REMARKS

Applicant hereby responds to the Office Action of Nov. 3, 2004, in the above-referenced patent application. Prior to this Reply, Claims 1-22 were pending in the patent application. Through this Reply, new Claim 23 has been added. A check in the amount of \$50.00 is enclosed to cover the required fee under 37 CFR §1.16(i). Accordingly, Claims 1-23 are now pending in the above-referenced patent application. Claims 19 and 22 have been amended to further clarify the limitations of the claimed invention. No new matter has been added. Claims 1-22 were rejected under 25 USC 102(b) as being anticipated by USPN 5,585,838 to Lawler et al (hereinafter “Lawler”).

Figure 2. A Second Functional Block Diagram of the ADTVR.

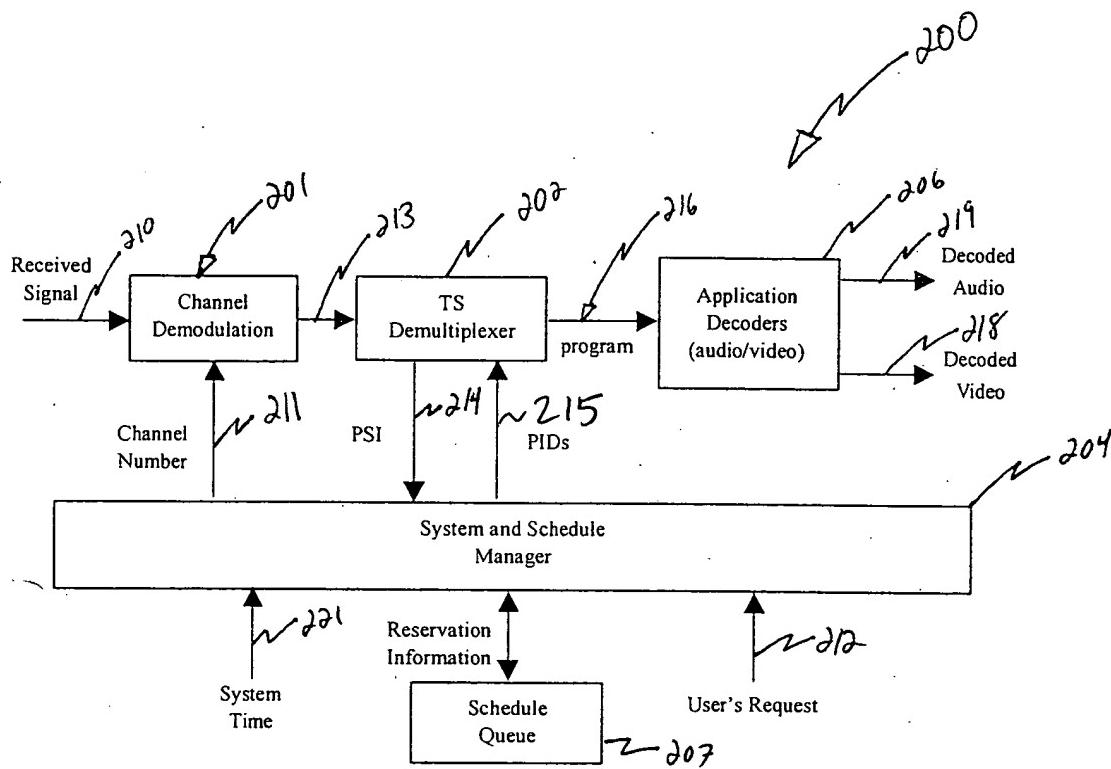
The Office Action objected to the drawings as failing to comply with 37 CFR 1.84(p)(5). The Applicant has herein amended the drawings to include reference characters not previously in the drawings, namely, 215 in Fig. 2, 416, 418 and 421 in Fig. 4. The Examiner contends that reference character 419 was included in the description but not in the drawings, however 419 was included in Fig. 4 to reference the control signal from the System and Schedule Manager 404 to the Output Video Formatter 408. Corrected drawing sheets are submitted herewith.

The Applicant has herein amended the specification to include reference characters not previously mentioned in the description, namely, 123, 119, 219 and 323.

The specification and drawings should now be in accordance with the Examiner's suggestions, and a withdrawal of the objection is respectfully requested. Three replacement sheets and corresponding annotated sheets for Figs. 2, 3 and 4 are enclosed (total 6 pages).

Figure 3. Third Functional Block Diagram of the ADTVR.

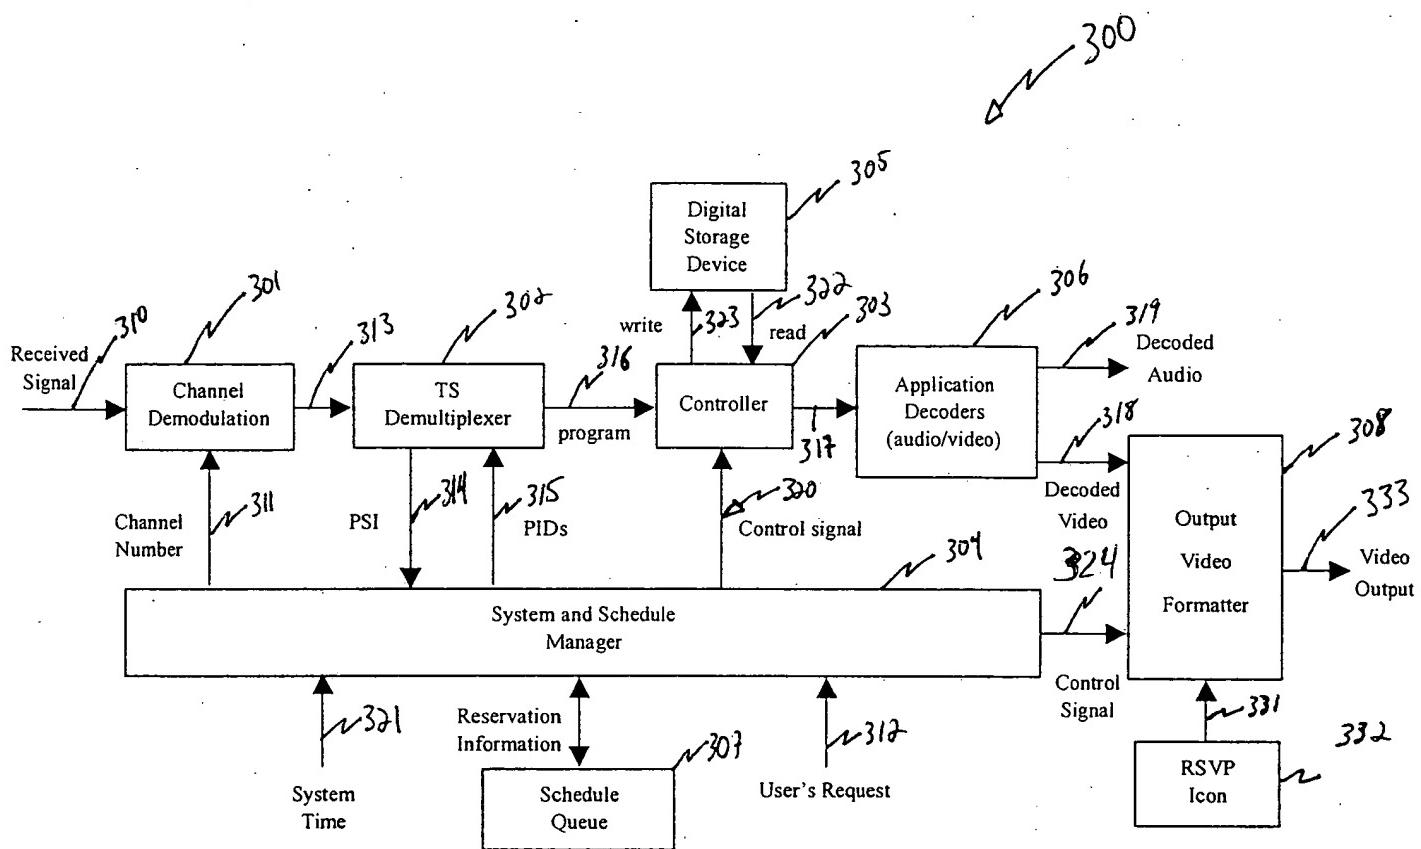
The specification has herein been further amended to clarify the referencing of character 319. Previously, character 319 referenced both a decoded audio and a control signal. As amended, reference character 319 designates a decoded audio, and reference character 324 designates a control signal in Fig. 3.
